**Standard configuration of  
2nd Generation DAC for  
DAC III or CD III**

**Conversion of 2nd Generation DAC  
from normal DAC III use to work  
with DAC II or older Platinum  
DAC**

# **2nd Generation DAC MODULE conversions**

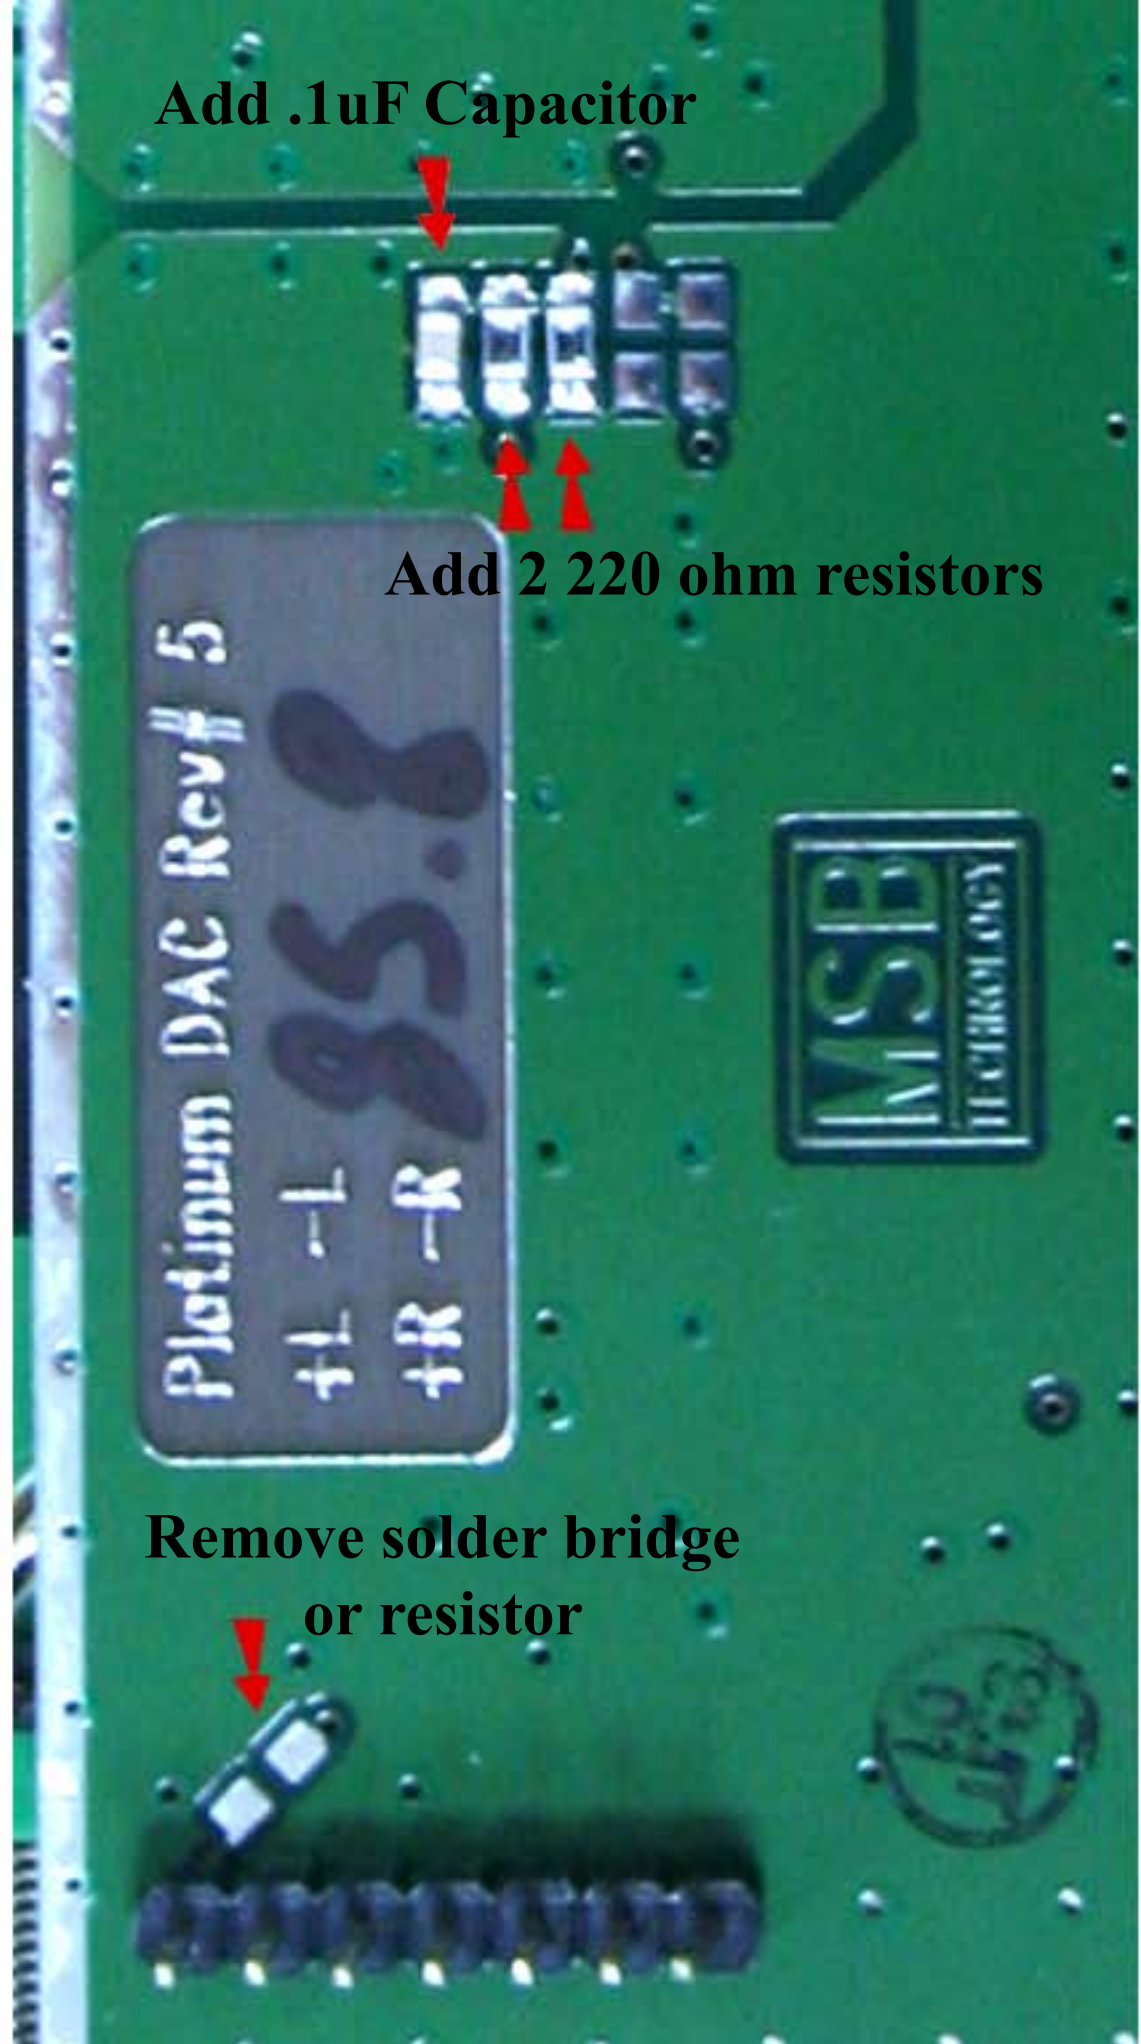
**Remove 3 parts**

**Solder bridge**

**Follow these steps to convert  
from DAC II to DAC III**

**Add .1uF Capacitor**

**Add 2 220 ohm resistors**

**Remove solder bridge  
or resistor**
